Highway Improvement Request Form Calstone A4 Junction

Cllr John Barnes
Highways, Transport & Road Safety Working Group

The photograph below was taken on 15th July and illustrates the issue.

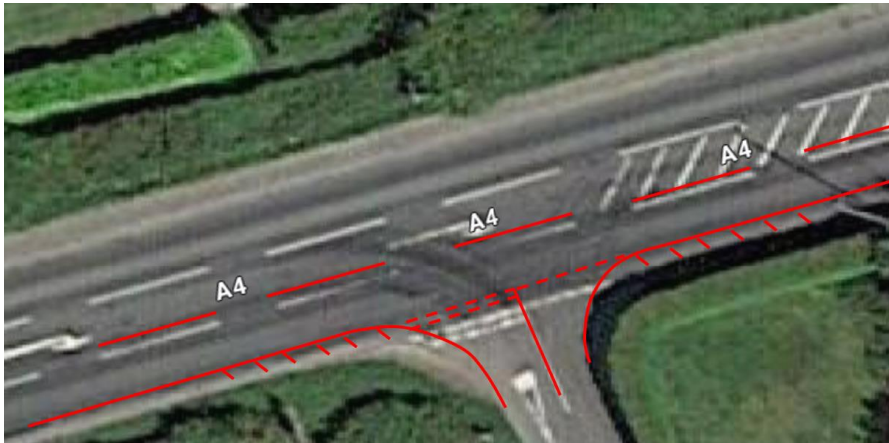
The issue raised is that vehicles turning onto the A4 from Calstone have very poor visibility with regard to traffic approaching from the direction of Cherhill due to the presence of a large hedge close to the road. Residents are concerned about safety in pulling out onto the A4, which is under the national speed limit at this location.

According to publicly available data, there have been no recorded accidents at this location in the last 10 years. There was a fatal accident in October 2001 and serious accident involving three vehicles in February 1999. Nevertheless, the visibility for turning onto this fast road is extremely poor and therefore hazardous. Many local residents are understood to avoid using this junction for this reason.

The hedge is on the boundary of the property and is privately owned. Nevertheless, it could be cut back where it impinges on the highway boundary, or alternatively, the Highway Authority could require it to be cut back or removed under Section 79 of the Highways Act 1980.

A further option might be to slightly narrow the width of the right turn lane to allow the Give Way lines to be pushed forward, by approximately 0.5m, to improve the line of sight. The alignment for westbound traffic on the A4 would need careful consideration.
